Pre-Filed Testimony of K.M. Leytham

**Submitted on behalf of Appellant
Airport Communities Coalition**

**PCHB No. 01-160
*ACC & CASE v. Dept. of Ecology & Port of Seattle***

February 22, 2002

Drainage Summary [ac-ft] 400 *
 * 1998 Embankment Fill Sedimentation Road

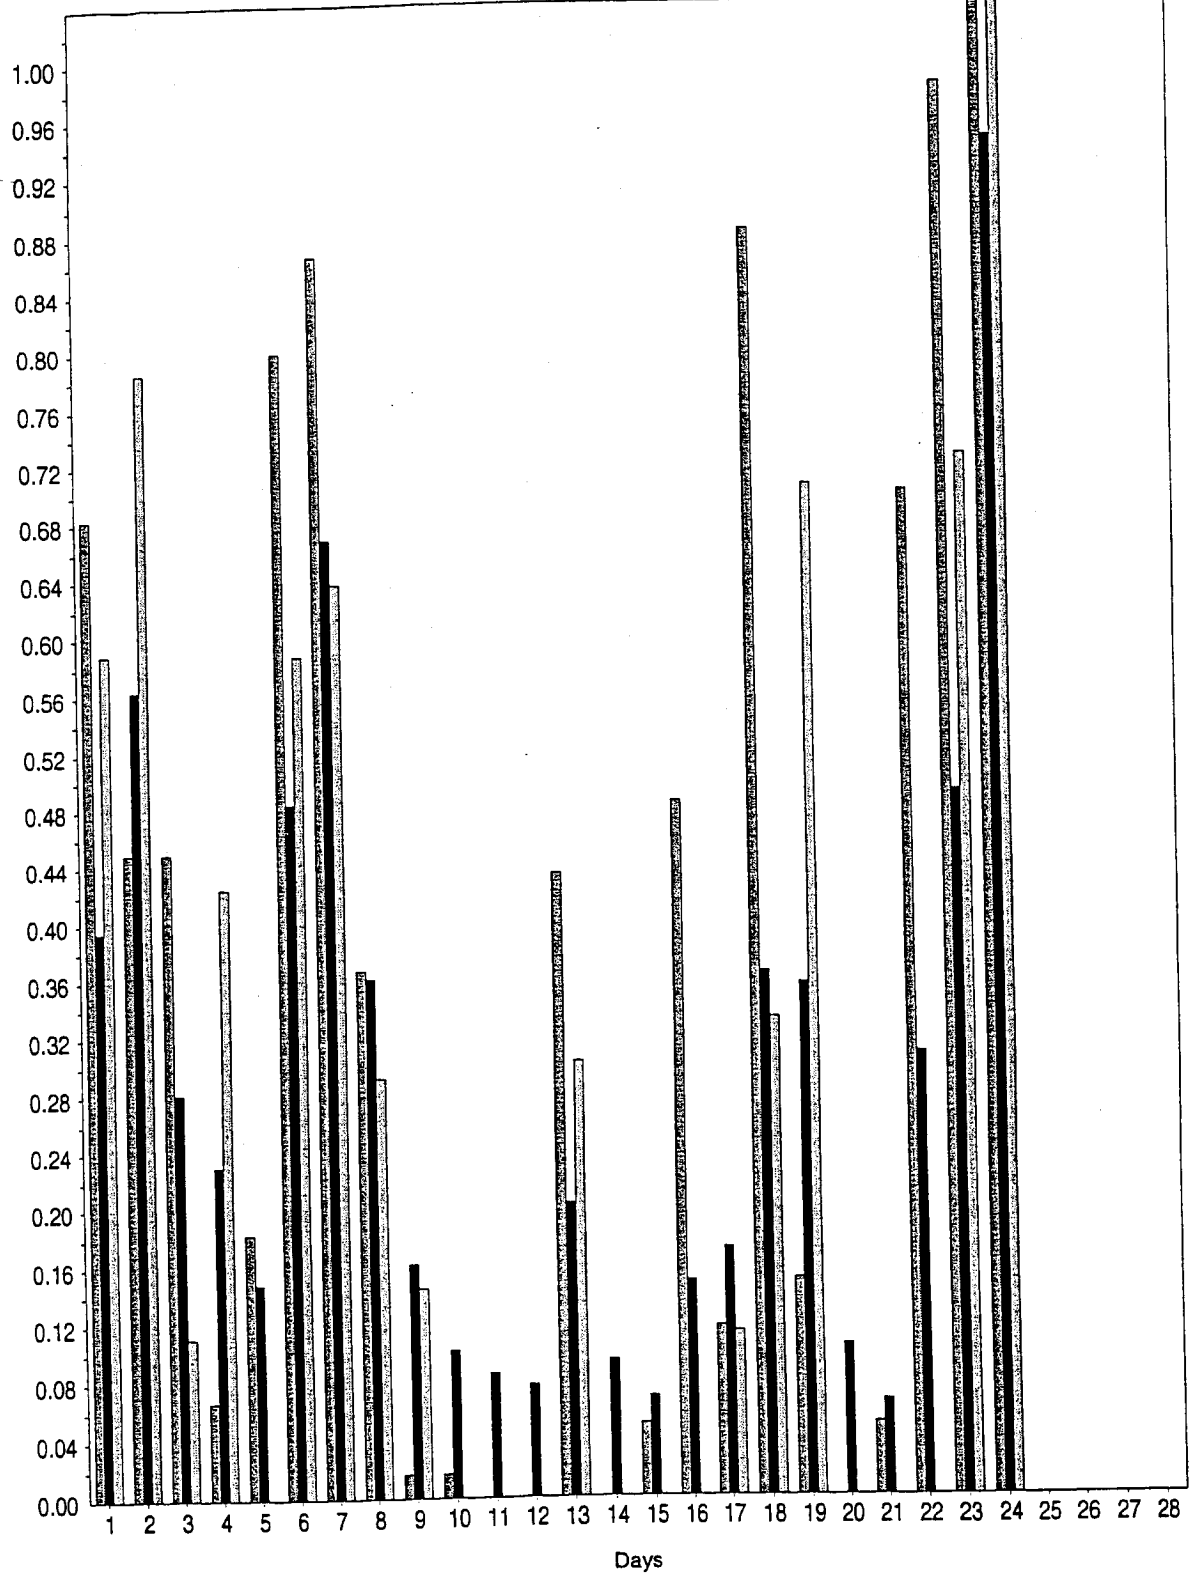
25. In order to characterize the hydrology of the proposed fill embankment, HPSF was calibrated against one month of observed runoff data (from February 1999) from a 19.4-acre area of the 1998 embankment site. The calibration results are presented in Appendix A of the SMP. The observed runoff from the embankment is flashy with high peaks and low base flow indicating low infiltration rates and significant amounts of surface runoff. The resultant HSPF model parameters show a hydrologic response similar to that of native till soils. Key HSPF model parameters for the embankment fill are summarized in Paragraph 28 below. Model simulation results, shown in **Exhibit H**, are adequate given the short period of observed data but tend to understate peak flows and overstate base flows. The period for which observed data are available was reasonably wet with total rainfall over the month of February 1999 of 6.95 inches and 1.04 in the wettest 24-hour period. By way of comparison the 2-year 24-hour rainfall for SeaTac Airport is approximately 2.0 inches. A longer period of observed runoff data from the embankment fill is needed to provide better confidence in model results.

Exhibit I: Standing water on the top of the fill embankment at about South 160th Street, 28
January 2002

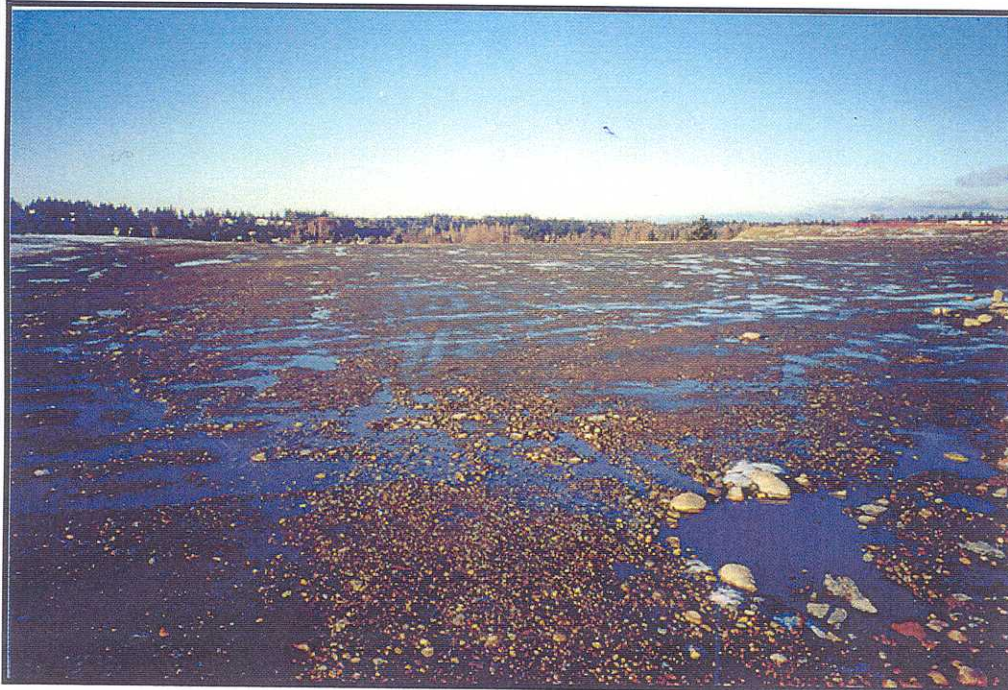
34. I, and other experts representing the ACC, had an opportunity to view a largely completed section of embankment during a site visit on the afternoon of January 28, 2002. Conditions during the visit were cold (temperatures probably in the mid-30s) and sunny with no rain. There were small amounts of snow on the ground in places (less than 0.5 inches) from snow over the previous 24 to 48 hours. Runoff from melting snow was flowing across the surface of the embankment and there were a large number of shallow puddles of standing water as shown in the photographs in **Exhibit I**. The surface runoff and standing water indicate low surface infiltration rates. These qualitative field observations are generally consistent with the observed runoff data from the 1998 embankment fill, which as noted earlier was apparently discounted by the Port. While the embankment appears to contain a relatively high percentage of coarse material, it is evident that there are sufficient fines to effectively seal the surface. Although I have not had the opportunity to view the embankment during rainy conditions, it is

evident from the surface runoff and standing water from melting snow that the embankment in its present state will produce large amounts of surface runoff during rainfall, with comparatively little infiltration. Completion of the embankment will presumably include some final grading, importation of topsoil, and seeding which will have some influence on its final hydrologic response. However, my qualitative field observations indicate that the completed embankment will likely produce much greater amounts of surface runoff and correspondingly less infiltration than has been assumed by the Port in its preparation of the December 2001 Low Flow Plan.

Exhibit J: Exposed face of fill embankment at site of slope failure near South 160th Street showing distinct layering and lack of homogeneity, 28 January 2002

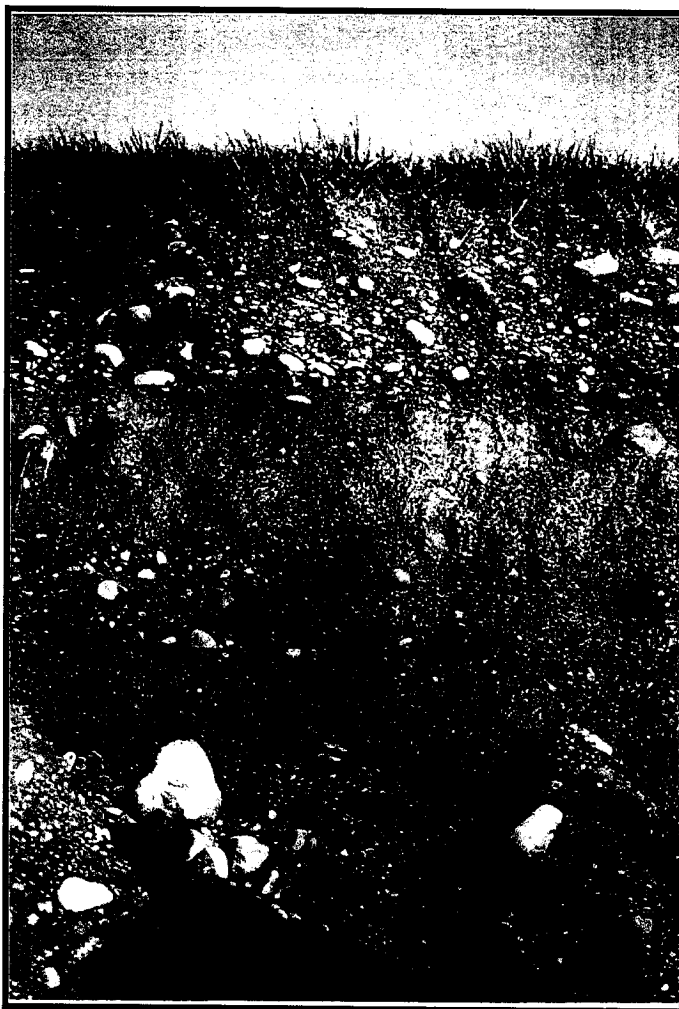
35. In addition to low permeability at the surface, it is evident that the embankment contains layers or lenses of low permeability material at depth in the fill. Several small slope failures in the face of the partially completed embankment were observed during the January 28, 2002 site inspection. The exposed face of the embankment, shown at one location in the photograph in **Exhibit J**, revealed layers of low permeability material which impede the downward movement of water and which can be expected to contribute to a faster lateral subsurface stormwater response than assumed by the Port.
